City Council Study Session Agenda Bill

AGENDA ITEM: (6:10 PM) Present the Groundwater Management Plan Peer Review - Public Works,

Technical Peer Review of the City of Bainbridge Island 2nd Draft Groundwater Management Plan

October 9, 2025

Figure 4. Distribution of glacial till (Qvt). From Figure 9 in Frans et al. (2011)

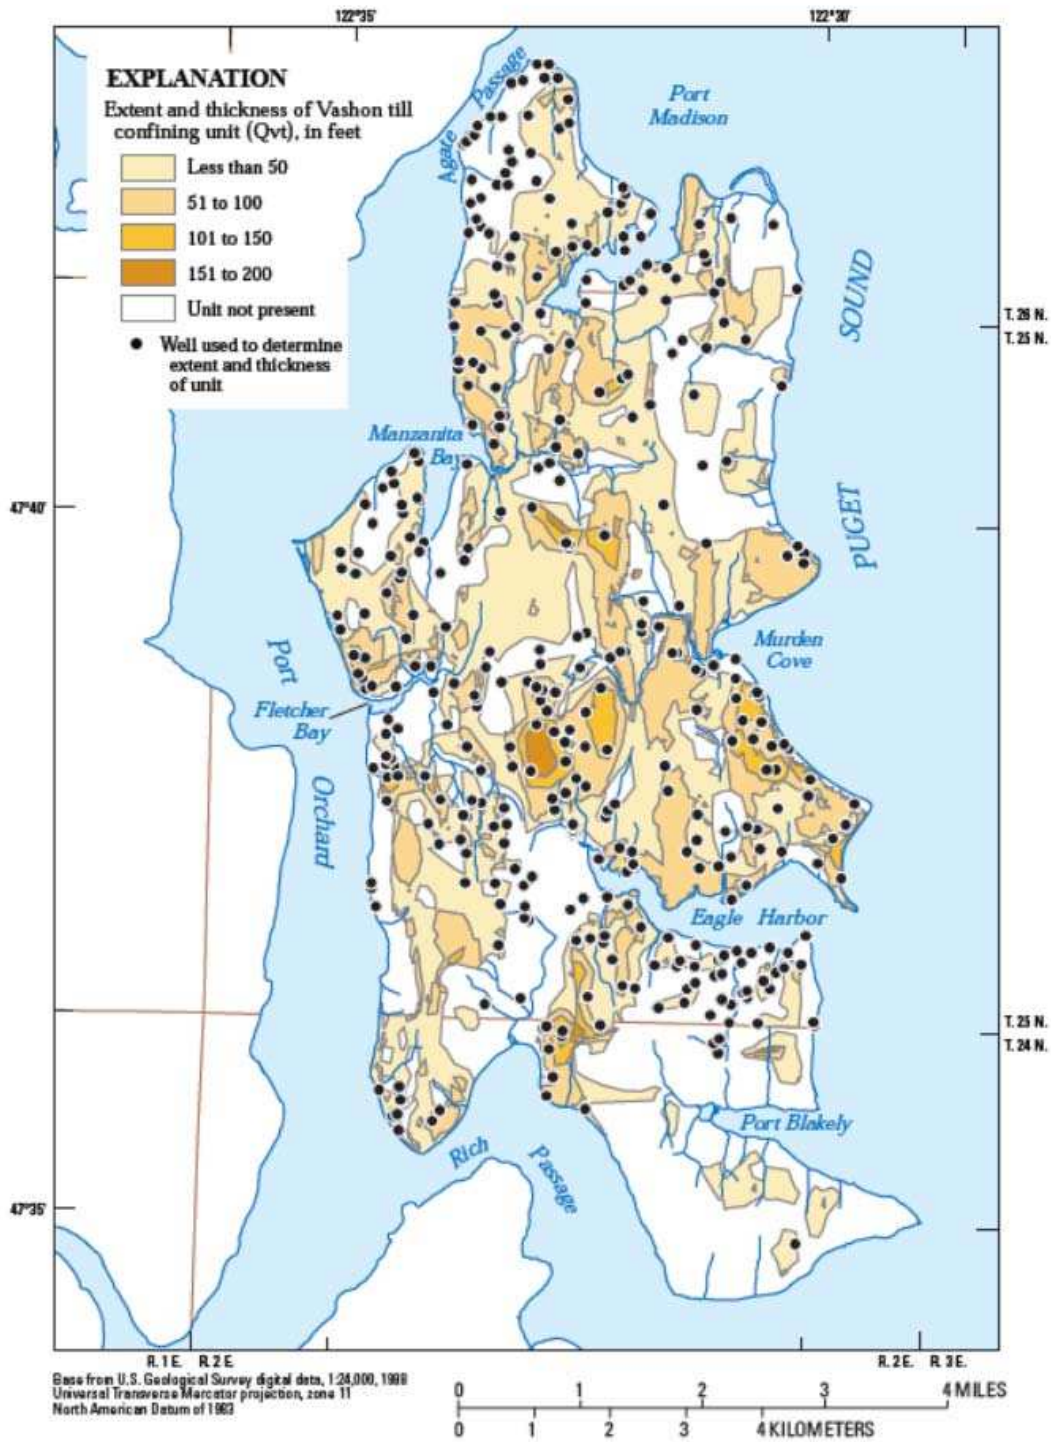
Combining the upper three layers essentially reduces the impact of the till layer. Figure 4 shows the estimated distribution of till on Bainbridge Island (from Figure 9 in Frans et al., 2011). The till layers are described by Frans et al. as follows: *“The till is a very compact mix of sand and gravel in a clay matrix and is somewhat discontinuous due to erosion by streams.”* These till areas likely affect the magnitude and distribution of impacts from shallow wells and the amount and discharge to streams and wetlands. The model as currently implemented has limited capability to simulate groundwater/surface water interactions, even if the layers had not been combined. These limitations are due in large part to the drain boundary conditions that are applied to all cells at the land surface in the model.

Figure 1. Vertical hydraulic conductivity (Kv) values for the QC2 (left) and QC3 (right) confining units. All values in ft/day.

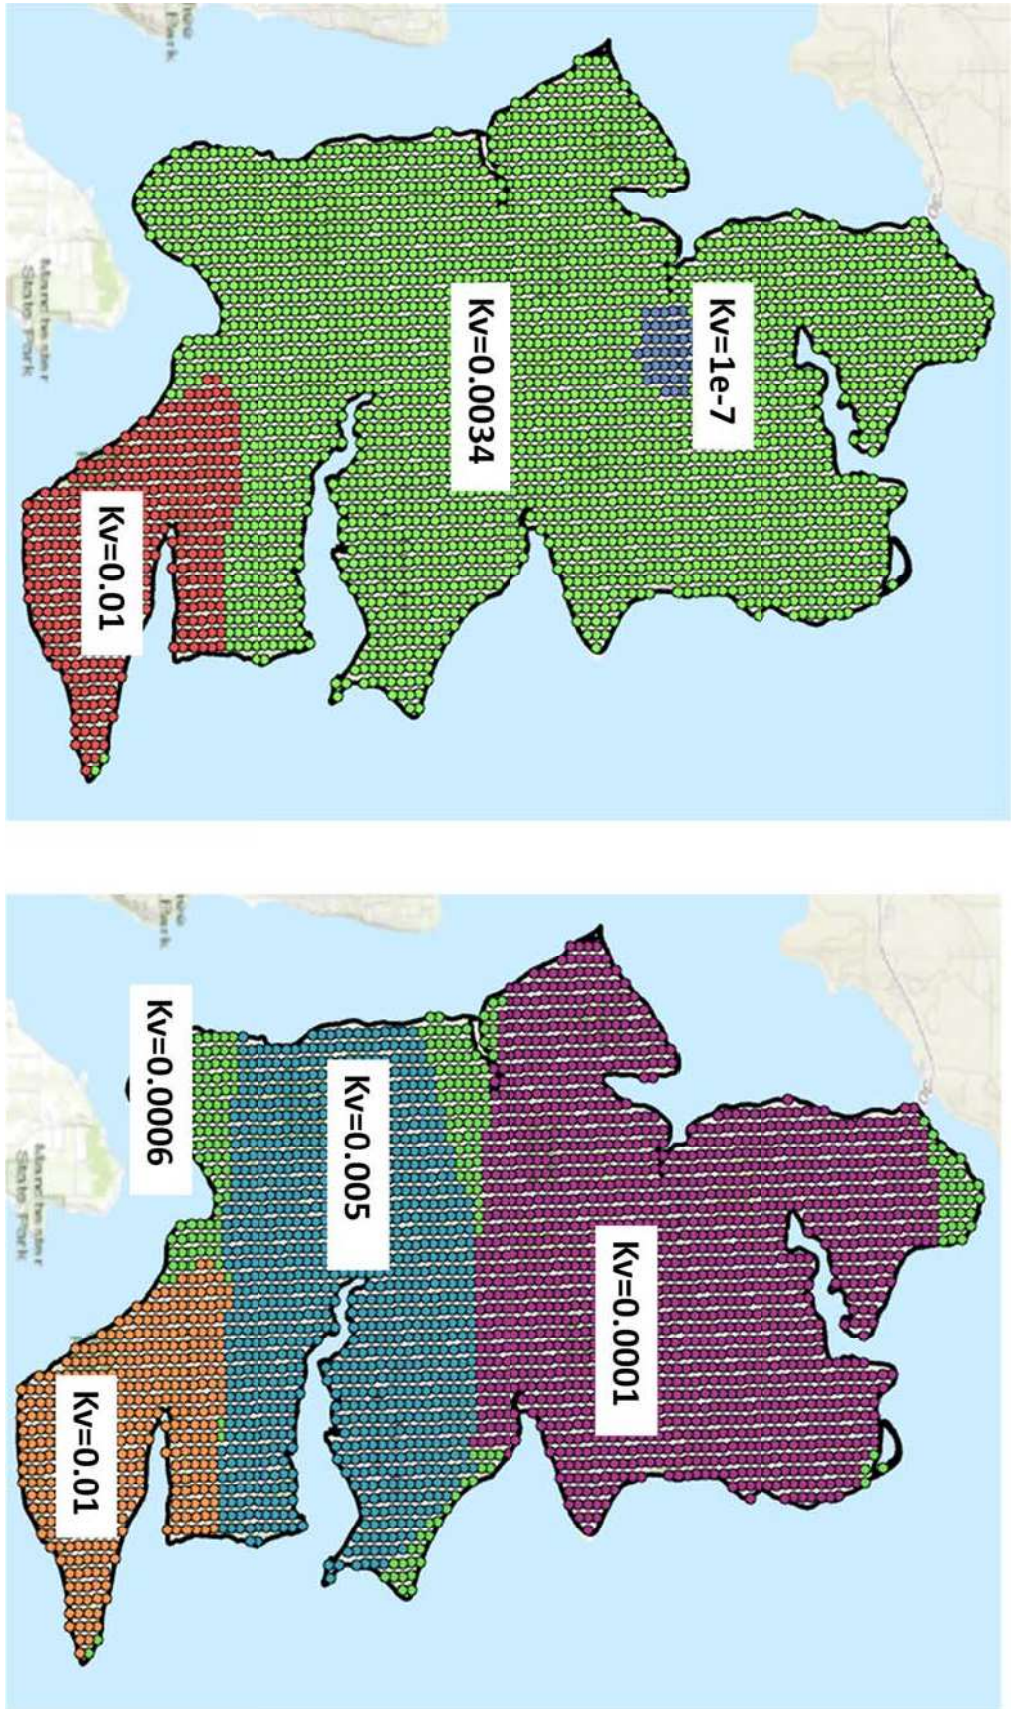
Figure 1 shows the distribution of vertical hydraulic conductivity values in the QC2 and QC3 confining units in the EA 2025 model. These values are not based on direct measurements, but rather were selected during model calibration.

Figure 2. Plot of observed and calculated groundwater elevations as shown in Figure 4 from the EA groundwater modeling technical memorandum (EA, 2025b)

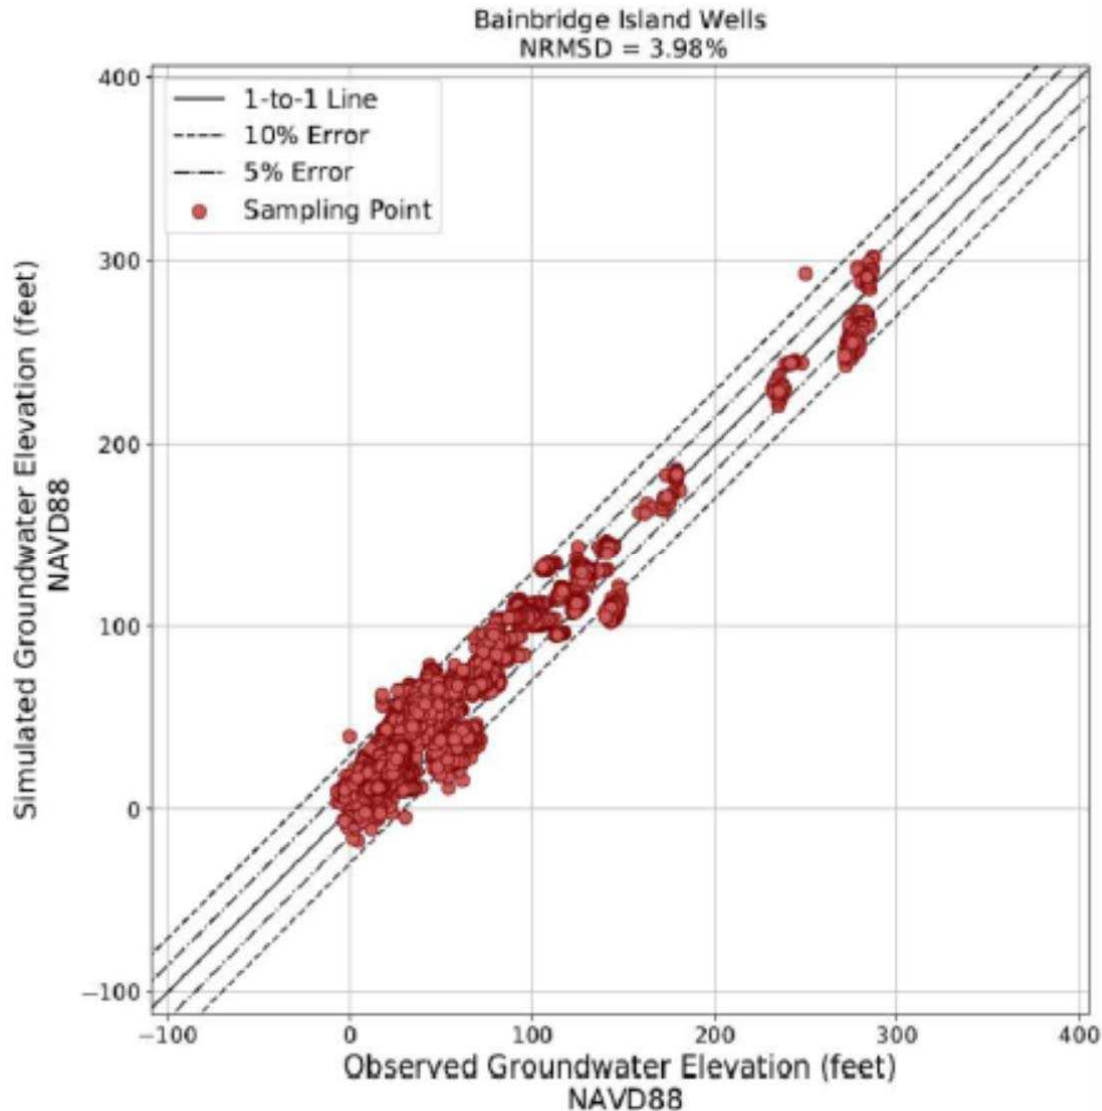
Figure 4 in the EA Groundwater Flow Model Technical Memorandum (EA,2025b) is used to describe the model calibration. The figure is reproduced below as Figure 2. The following excerpt from the EA memorandum is used to describe the figure:

Figure 4 in the EA memorandum and its associated description present a misleading assessment of the calibration statistics. The dashed lines do not show 5% and 10% error. Rather, it appears that the +/-10% line actually shows plus or minus 30 feet, which is approximately 10% of the largest water level value shown on the graph. Most of the water levels are significantly less than 300 feet, and a 30-foot error is significantly larger than a 10% error.

Figure 3 presents an alternative approach for showing the $\pm 10\%$ error lines and compares these lines to the observed and calculated groundwater elevations in the range of 0 to 100 feet.⁸ As an example, the $\pm 10\%$ error line for an observed water level of 30 feet is ± 3 feet. The difference between observed and calculated groundwater elevations is significantly larger than 3 feet for those observations in the vicinity of 30 feet. Most of the calculated water levels shown in Figure 3 fall significantly outside the $\pm 10\%$ lines.

Figure 4. Plot of observed and calculated groundwater elevations derived by running the model provided as part of the peer review process.

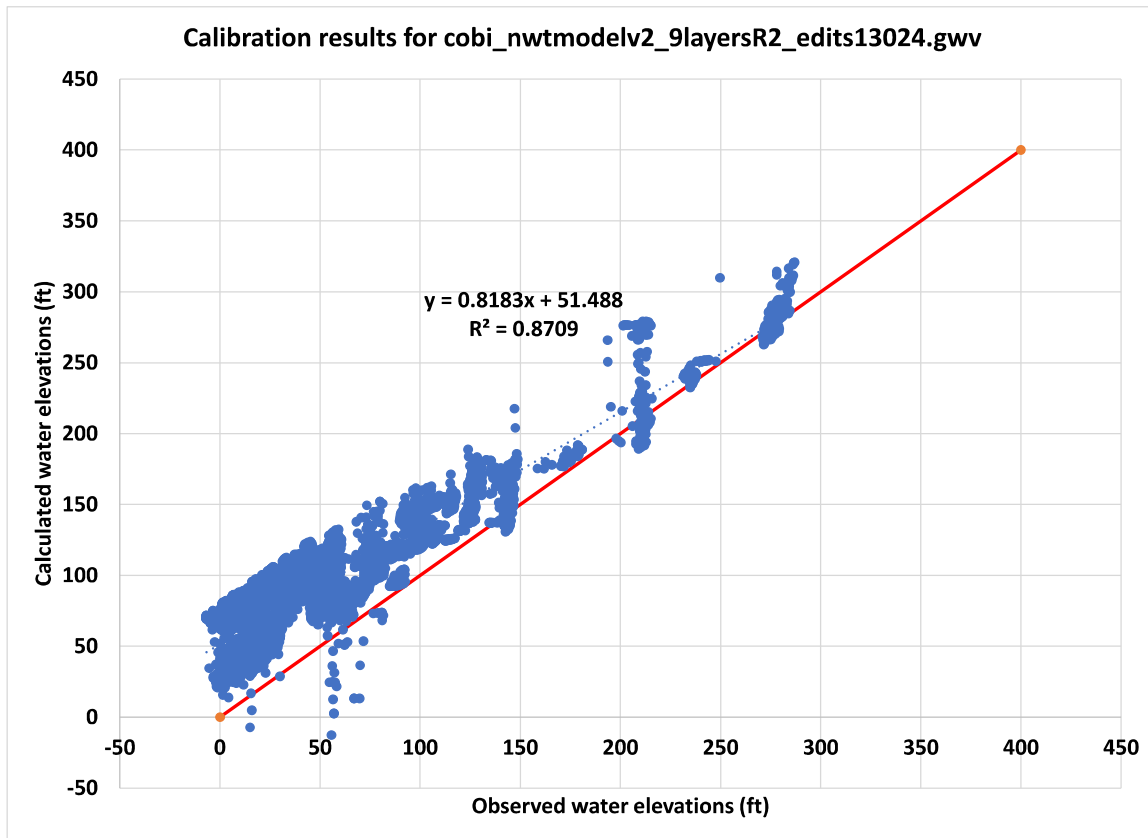
As part of our peer review, we ran the EA model and graphed observed and calculated water level elevations for wells on Bainbridge Island.⁹ The results are shown in Figure 4. A comparison of these results with the results included in the July 2025 tech memo (reproduced in Figure 2 above) shows significant differences. In particular, the calculated water levels from our simulations are approximately 50 feet higher than the observed levels.

In response to the results shown in Figure 4, we emailed EA Engineering on September 4, 2025 asking if there was a different model version.¹⁰ We heard back on September 18, 2025 that there was not a different version.¹¹ We have therefore assumed that we have the model version that was relied upon in developing the GWMP.
